Access Compliance Report

Public Rights-of-Way

| Intersection ID: 29723 | Main Street: LANNIER FALLS LN | Cross Street: MEDOC MOUNTAIN DR | Location: | N |
| ADA ID: 4705E80E9F7C | Ramp Type: PerpDiag | Initial Pass/Fail: Fail | Overall Compliance: No | Severity Score: 10 |

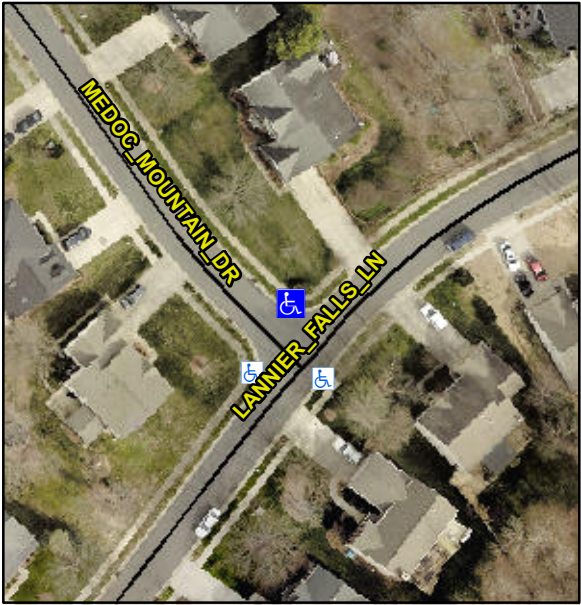
| Codes/Mitigation Info/Possible Solution | | Field Measurements/Component Compliance | | | |
|---|--|--|-------------------|--------------------------|-------------|
|  <p>Street 1 Name MEDOC MOUNTAIN DR</p> <p>Stop Condition-Street 2 StopSign</p> <p>Street 2 Name LANNIER FALLS LN</p> <p>Stop Condition-Street 1 None</p> | <p>Possible Solutions:</p> <p>Remove & Replace Curb Ramp With Two New Directional Ramps or Equivalent.</p> <p>Surveyor Notes:</p> <p>N/A</p> <p>PROW/ADA:</p> <p>R304.5.1, R304.5.3</p> | <p>Total Cost:</p> <p>\$ 3200.00</p> | | | |
| | | | No | Ramp Width (in) | 44.0 |
